WILLIAMSON COUNTY, TEXAS

CHANGE ORDER NUMBER: 1

Project: 23IFB6

Roadway: CR 404 at FM 973

| <h1>TRANSVERSE OR IN-LANE RUMBLE STRIPS</h1> <h2>RS(5)-23</h2> | | | | | | | |

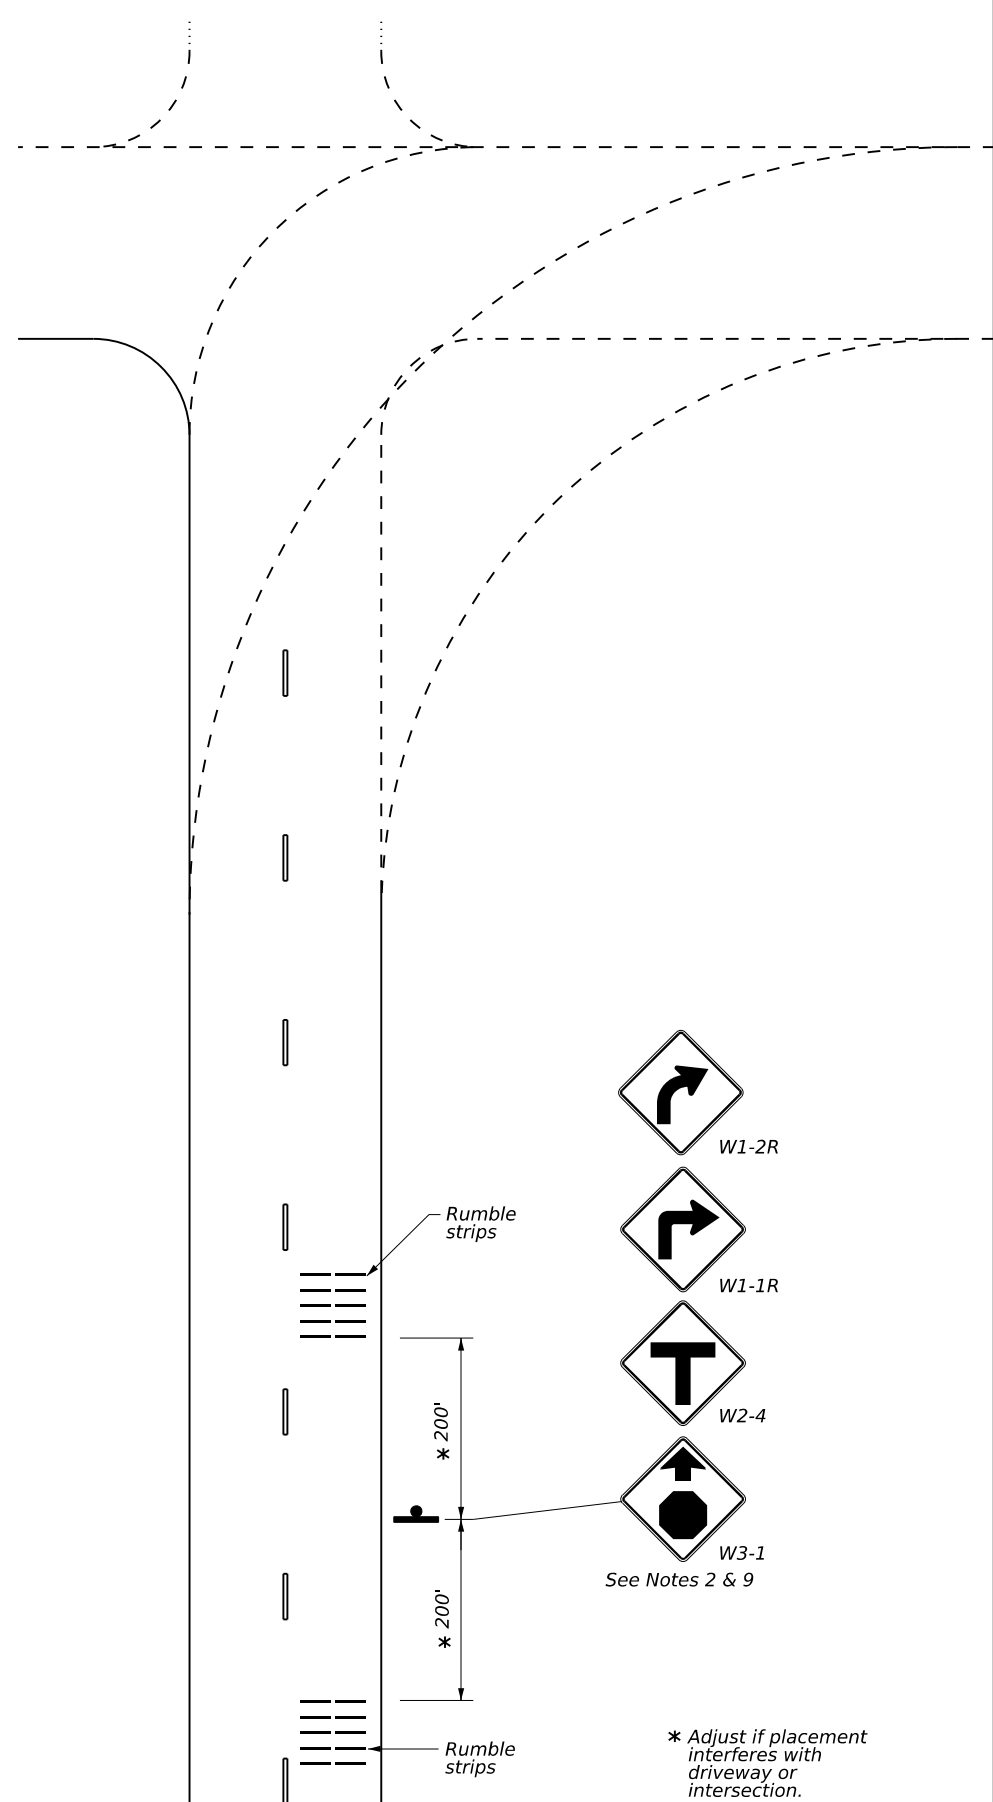
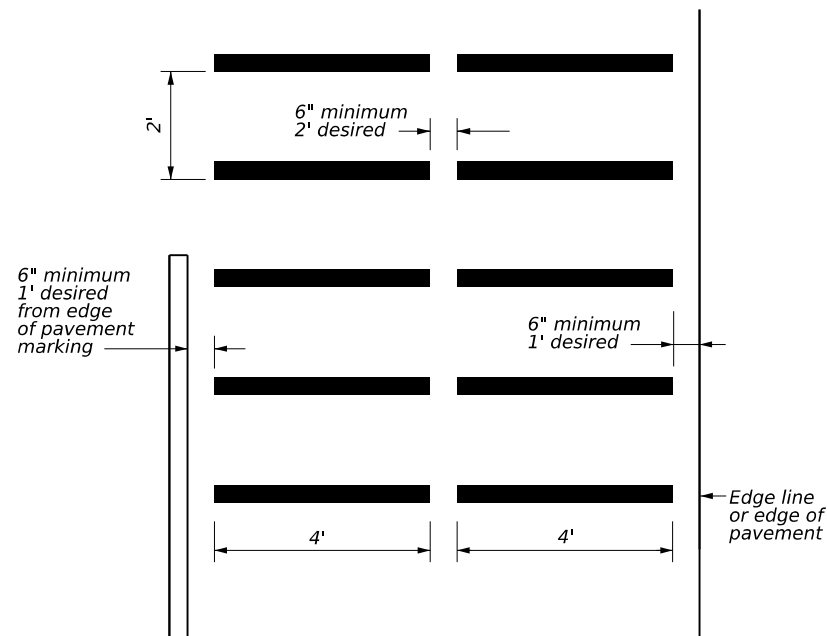
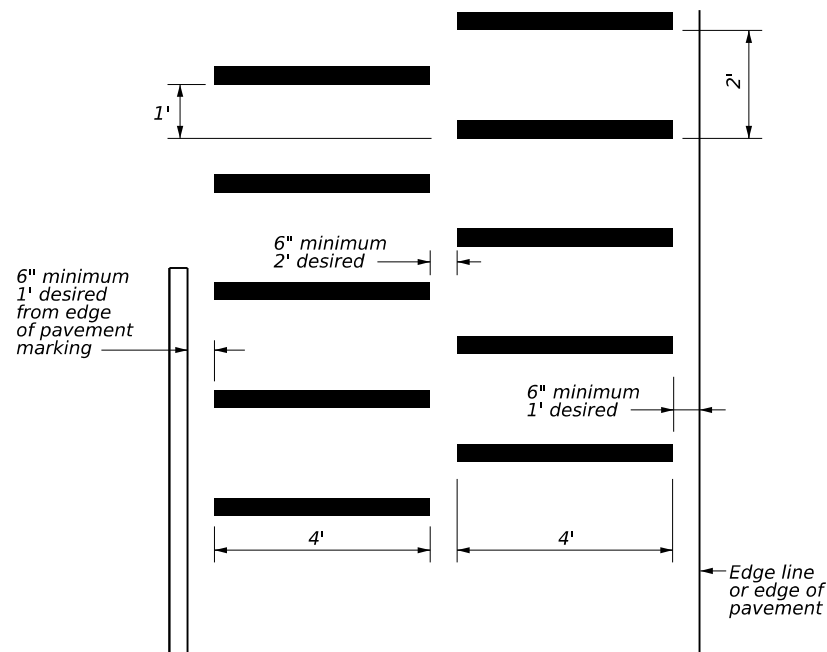
- Rumble strips were added at the request of Williamson County to bring awareness to the new traffic signals.
- Flexible pavement repair was needed due to asphalt failures in the existing FM 973 roadway.

1. *Transverse or in-lane rumble strips should only be used at high incident and special geometric locations. These special geometric locations may include: approaches to rural, high speed signalized or stop-controlled intersections with sight restrictions and/or high crash rates, approaches to unexpected urban intersections, approaches to newly installed stop or signalized controlled intersections, approaches to toll plazas, approaches to hazardous horizontal curves, and approaches to railroad grade crossings.*

2. *When used, the rumble strips shall be placed 200 feet upstream and downstream of the warning sign.*
3. *The use of rumble strips should not be widespread or indiscriminate.*
